South Texas Project
Units 3 and 4
Docket Nos. 52-012 and 52-013
Supplemental Response to Request for Additional Information

1. RAI 03.08.04-18, Supplement 4
2. RAI 03.08.04-23, Revision 1

RAI 03.08.04-18, Supplement 4**QUESTION:****Follow-up to Question 03.08.04-2 (RAI 2964)**

RAI 03.08.04-23, Revision 1**QUESTION:****Follow-up to Question 03.08.04-13 (RAI 2965)**

Figure 3H.6-48: Resisting Lateral Pressure on the East, West, and North Walls of Pump House (for Stability Evaluation)

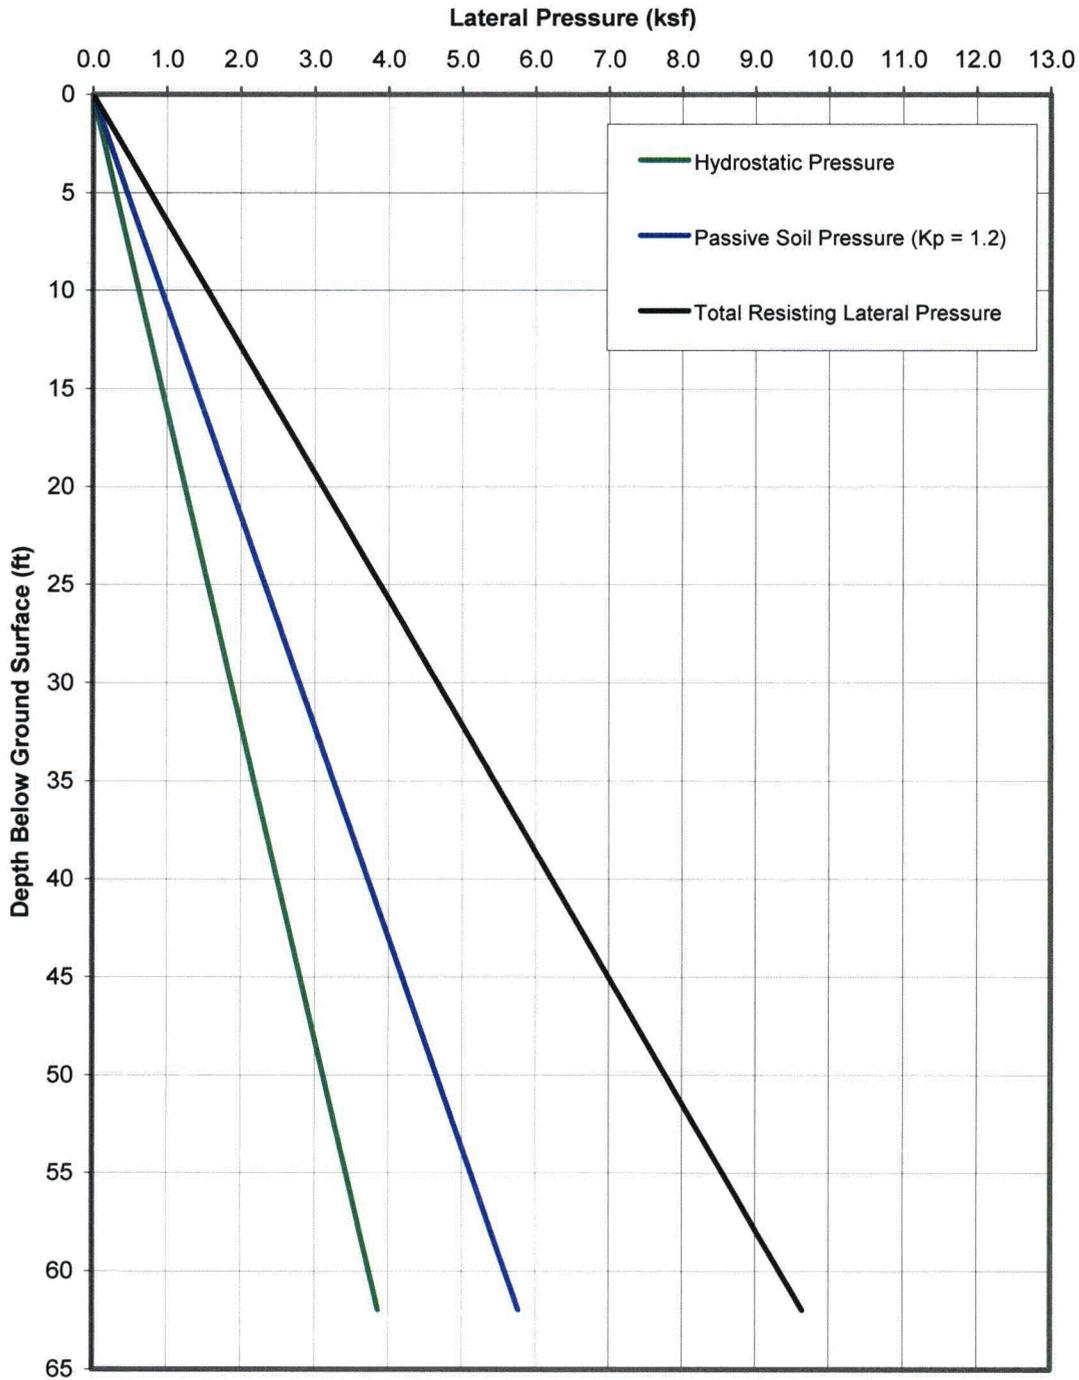
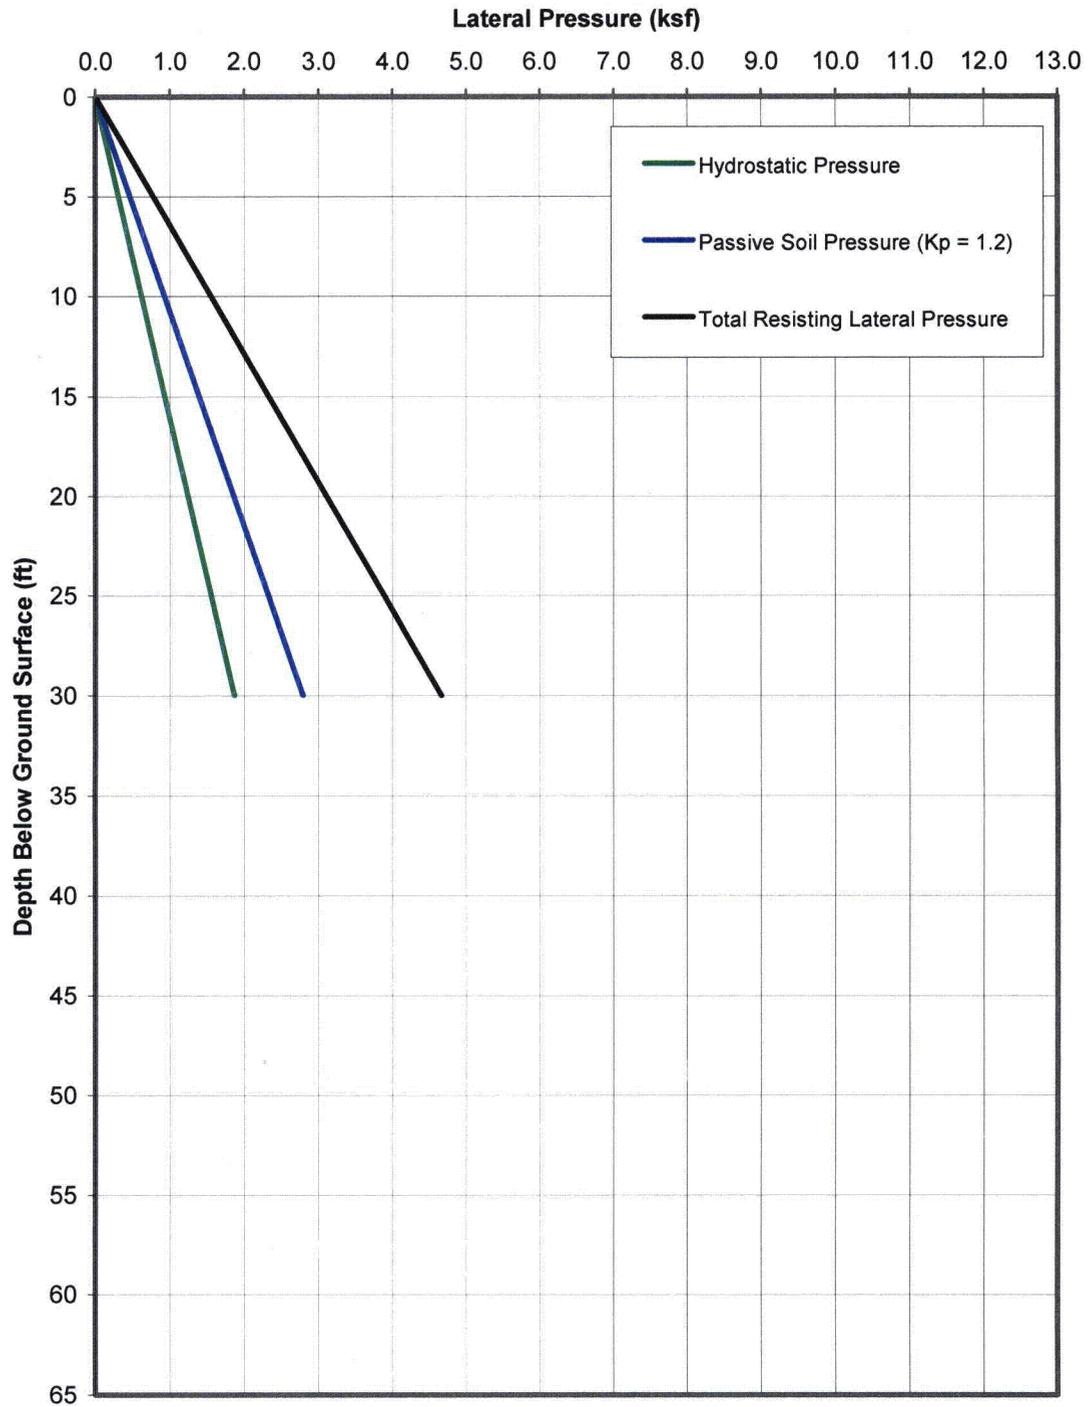
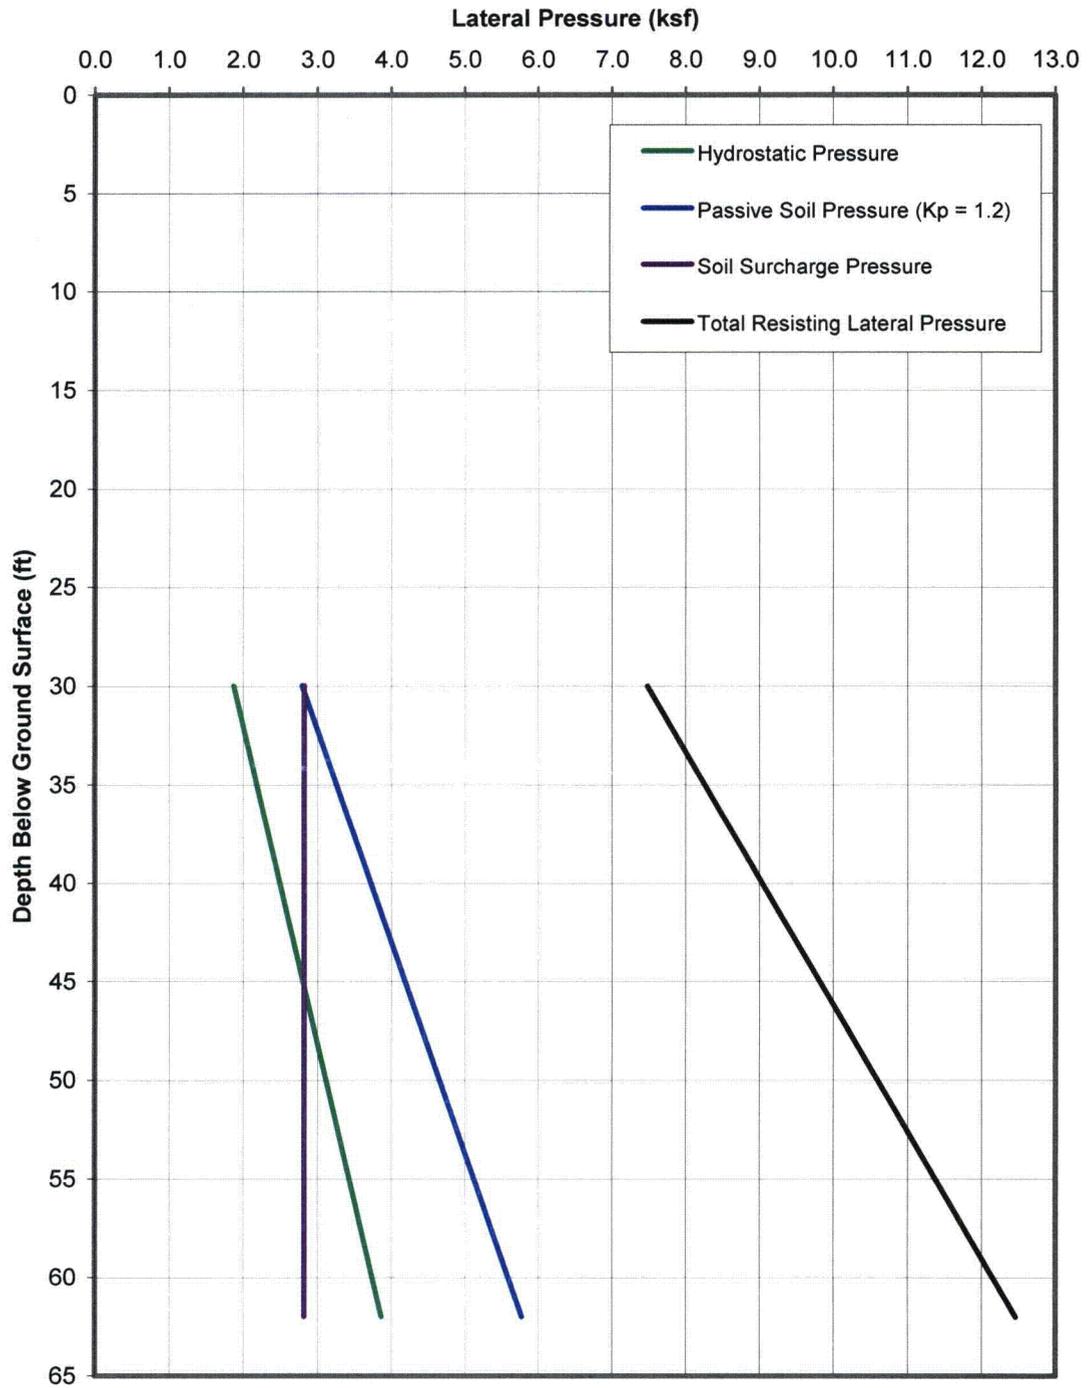
7. *Revise COLA Figures 3H.6-48 through 50 to show passive soil pressures needed for stability (Punch List Item 267)*

See Enclosure for COLA markup of Figures 3H.6-48 through 3H.6-50.

Figure 3H.6-137: Formulations Used for Calculation of Factors of Safety Against Sliding and Overturning for Category I Site-Specific Structures

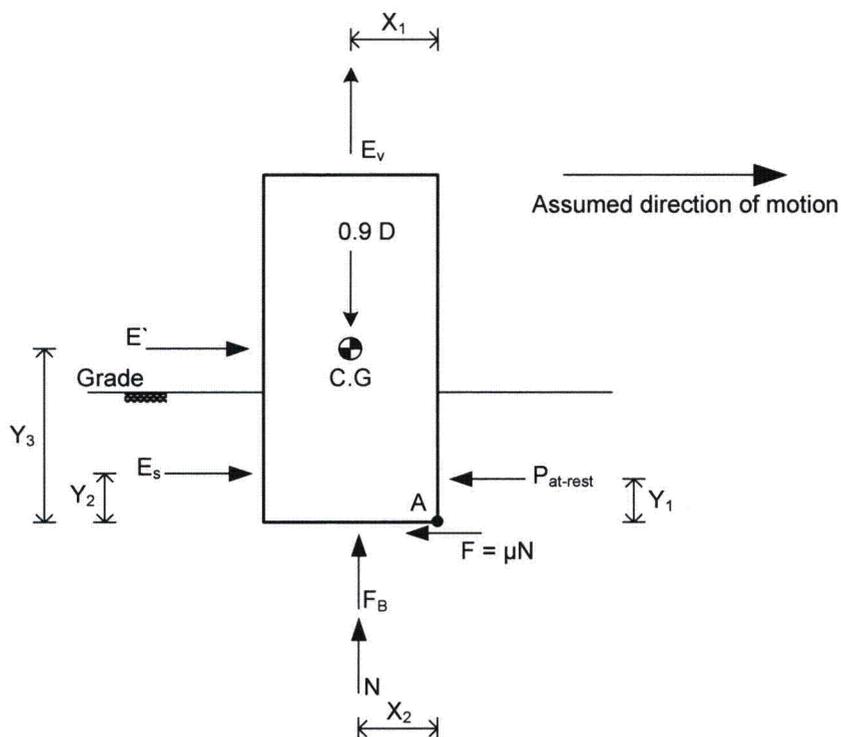
6. *Revise COLA Figure 3H.6-137 to remove reference to UHS figures (Punch List Item 266)*

See Enclosure for COLA markup of Figure 3H.6-137.

Figure 3H.6-40: SAP Finite Element Model for UHS and RSW Pump House Design

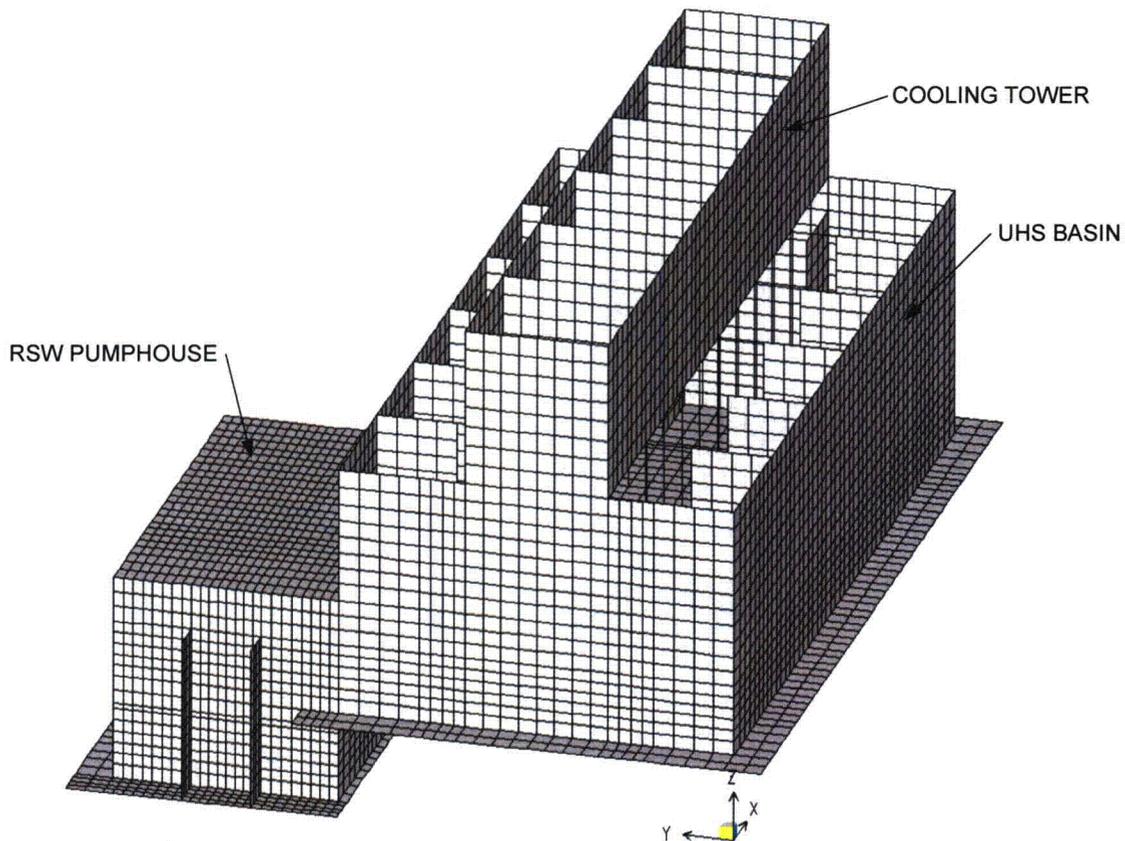
In its response to Question 03.08.04-13, the applicant referred to FSAR mark-up provided in response to question 03.07.01-13 for structural analysis and design information for site-specific seismic category I structures (Letter U7-C-STP-NRC-090112 dated August 20, 2009). The staff noted that the above referenced response did not include all tables and figures referenced in the FSAR mark-up, and these are stated to be provided later. In addition, the level of detail included in FSAR Section 3H.6.6.3 regarding structural design of the various elements of site-specific structures is not sufficiently descriptive, and is not similar to that included in the ABWR DCD. Therefore, the applicant is requested to include in FSAR Section 3H.6.6.3 description of the various steel and concrete elements of the site specific structures including how these elements are designed including design results.

A three dimensional Finite Element Analysis (FEA) as shown in Figure 3H.6-40, provided with Supplement 1 Response to RAI 03.07.01-13 (see STPNOC letter U7-C-STP-NRC-090208 dated November 19, 2009), is used for structural analysis and design of the UHS/RSW Pump House.
